RATIONALE

FITTING, ELBOW, 45°, INTERNAL
STRAIGHT THREAD PORT

AS5191™
SHEET 1 OF 3

REV.
C

FIGURE 1 - FITTING, ELBOW, 45°

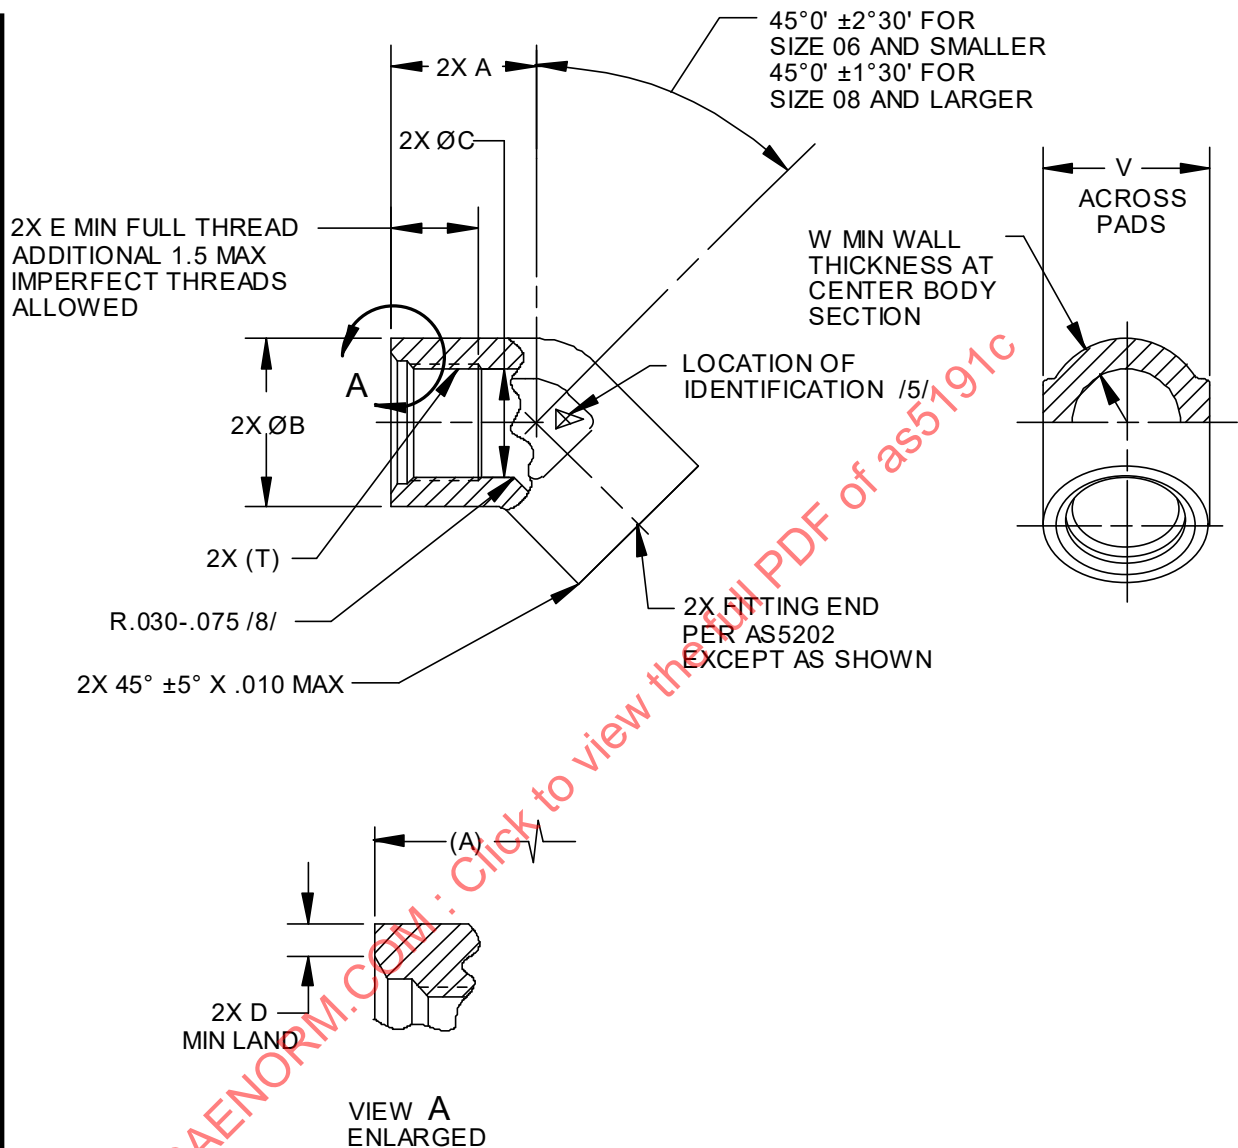
REVISE GRAPHICS AND TABLE 1, INTRODUCING NEW DIM E FOR ALLOWABLE MINIMUM THREAD DEPTH. SPECIFICATIONS SPECIFIED HEREIN UPDATED TO CURRENT NOMENCLATURE. "VAD" REMOVED FROM PROCUREMENT SPECIFICATION NOTE.
